SUBJ: RCRA Facility Assessment Report
Universal Waste & Transit, Inc.
EPA I.D. No. FLD 981 932 494

SUBJECT: *Universal Waste & Transit, Inc., FLD 981 932 494*
Comments on Draft RFA Report - Revised

TO: BILL CRAWFORD - E IV.
FROM: Doug / Bheem
SUBJECT: UW&T - ^{DRAFT} RFA REPORT - REVISED
DATE: MARCH 22, 1995

FIGURE 3
 UW&T GROUNDWATER MONITORING WELL LOCATIONS'

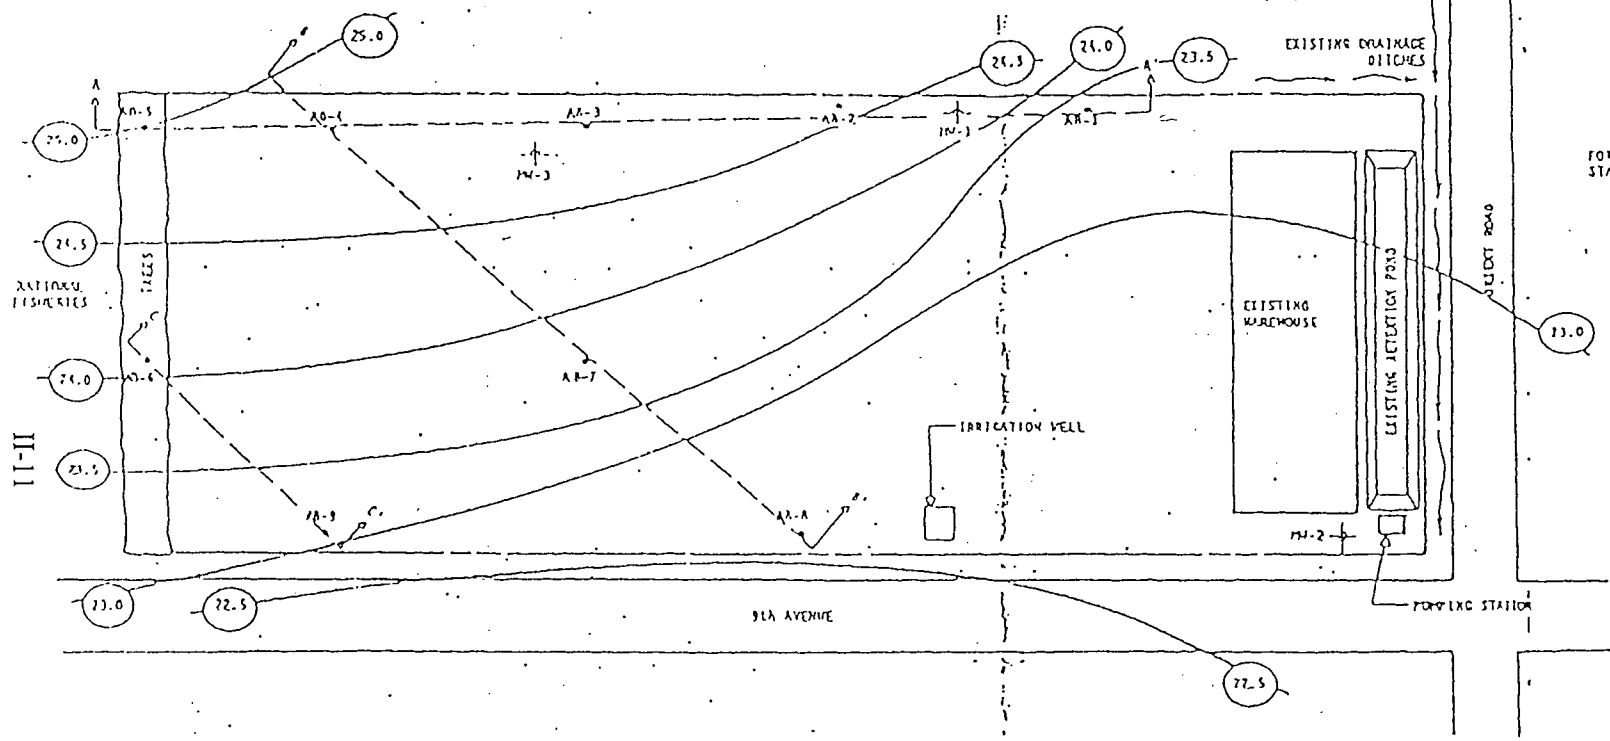
5. Figure 3 - Monitoring Well Location Map
This figure is illegible. Please replace this with a legible copy.

FDEP Response: The most legible copy of this figure has been provided.

FIGURE 4
 UW&T DRAINAGE PATH LOCATION MAP

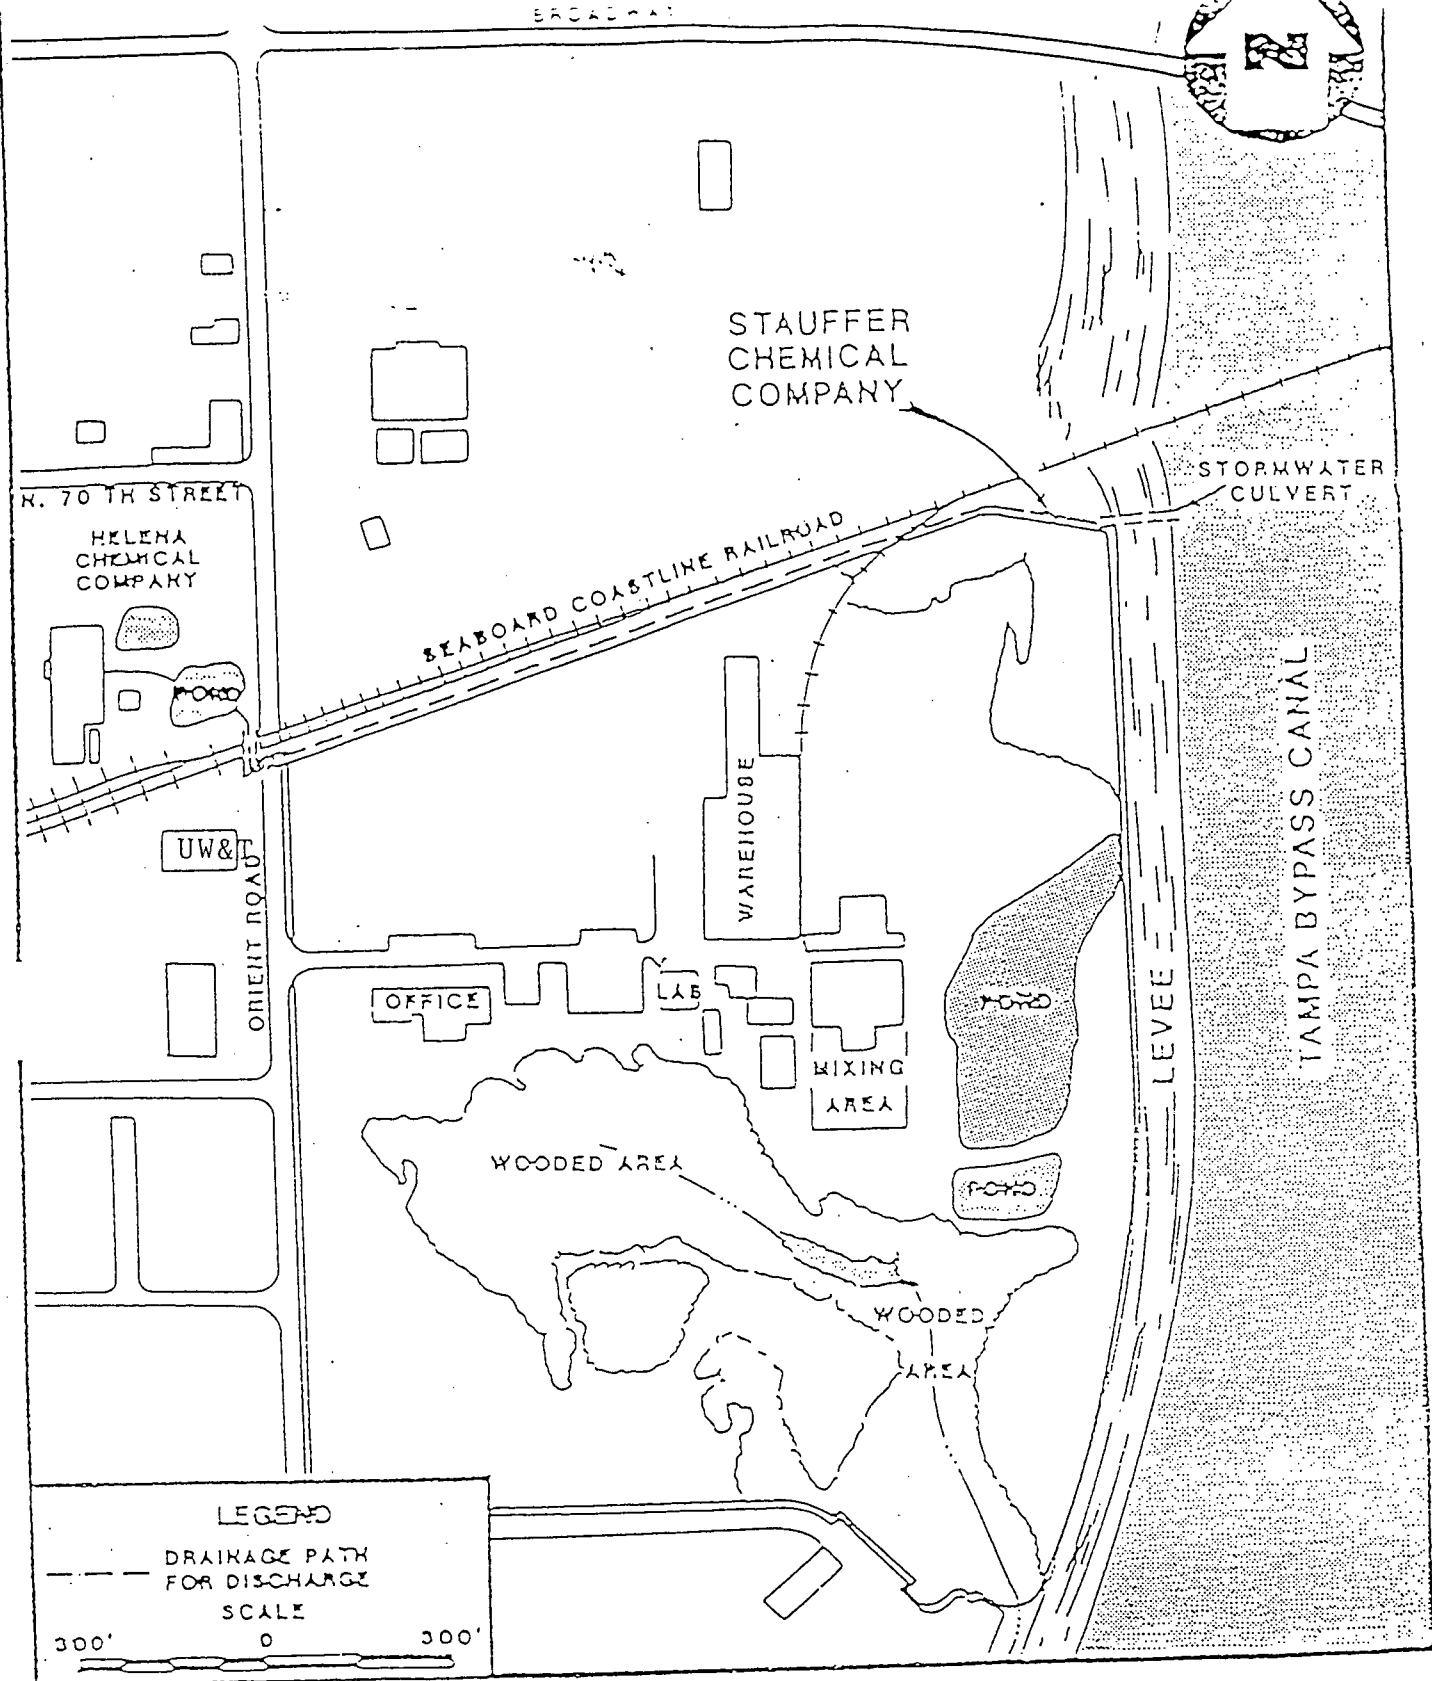
1. Topography and Drainage (p. II-13) Identify UW&T on Figure 4.

FDEP Response: UW&T has been identified on Figure 4.
